ECHOKNITS LTD (Extension)

A-99/1; Bokterpur; Kaliakoir; Gazipur

27 December 2023

2. Observation

Unbraced racks on floor

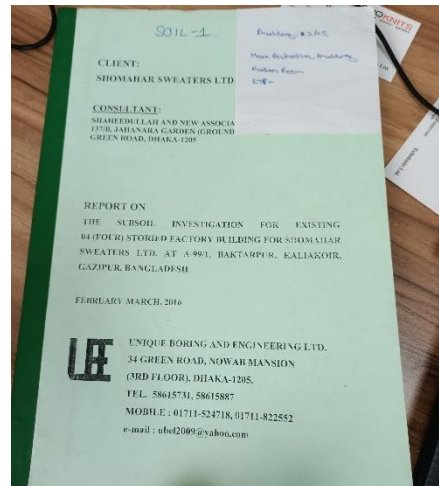
Observation-04: Non-structural elements are not anchored or braced. (Building-04 (General Store))

Description: Some racks on floors are not anchored or braced to resist lateral (earthquake) forces. The factory is required to anchor/brace all non-structural elements adequately to resist earthquake forces.

Parapet on roof

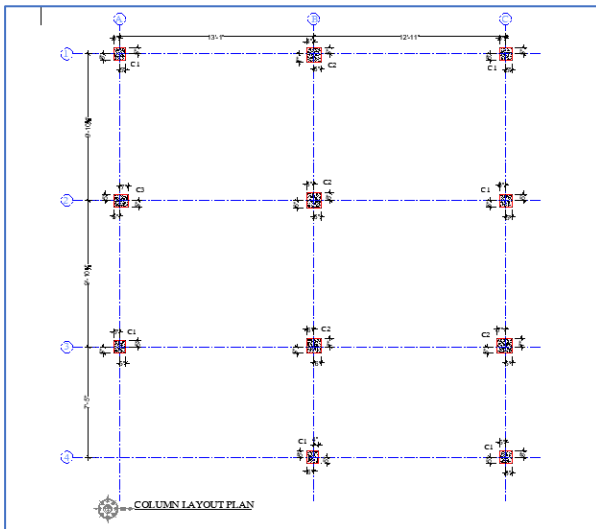
Observation-06: Falling hazard risk on roof. (Building-05 (ETP))

Description: Falling hazard risk was observed on the roof of ETP building. The existing parapet wall's height was found only 24 inches. Building engineer is required to increase the wall height at least 42 inches to mitigate the falling hazard risk.

Number of rebar by ferro scan

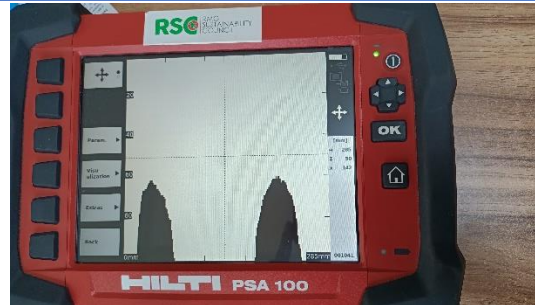
Observation-07: Discrepancies in as-built drawings. (Building-06 (Maintenance Building))

Description: Number of rebar in C-2 column was found 4 nos instead of 6 nos. Building engineer is required to survey the whole structure and prepare accurate as-built drawings.

Core cutting location

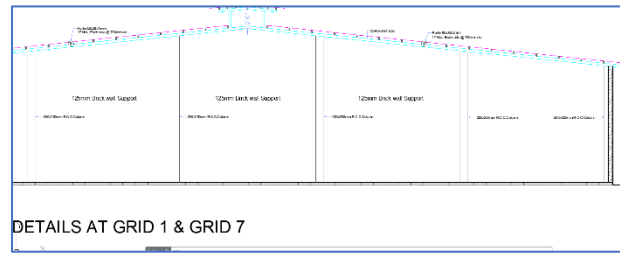
Observation-8: Lack of design report. (Building-06 (Maintenance Building))

Description: As per BNBC, every building or structure designed shall have its design documents prepared following the provision of Section 1.9.1. The design document shall include a design report, and a set of structural drawings, which shall be prepared in compliance with section 1.9.1.1 and section 1.9.1.2, part 6 of BNBC. On the other hand, core cutting location was found onsite but core cutting layout was not available. The building engineer is required to prepare the design report considering concrete strength based on core test report.

Racks

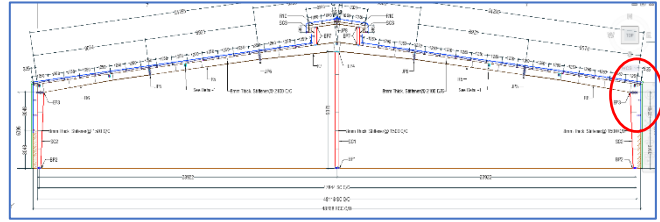
Observation-11: Non-structural elements not anchored or braced. (Shed-12 (Empty Carton Store))

Description: Some racks on floors are not anchored or braced to resist lateral (earthquake) forces. The factory is required to anchor/brace all non-structural elements adequately to resist earthquake forces.

Frame Section

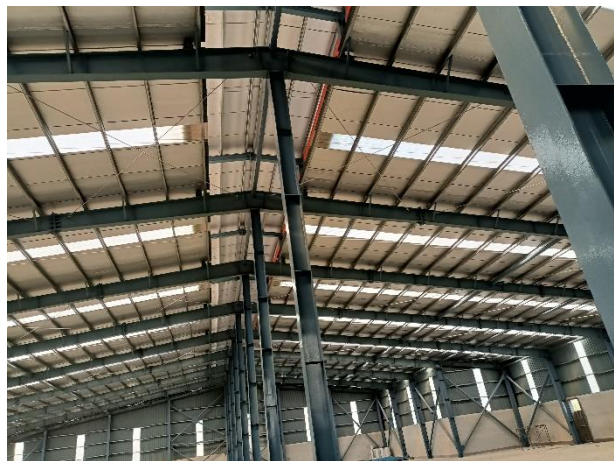
Observation-13: Lack of design report. (Shed – 13 (Warehouse))

Description: As per BNBC, every building or structure designed shall have its design documents prepared following the provision of Section 1.9.1. The design document shall include a design report, and a set of structural drawings, which shall be prepared in compliance with section 1.9.1.1 and section 1.9.1.2, part 6 of BNBC.
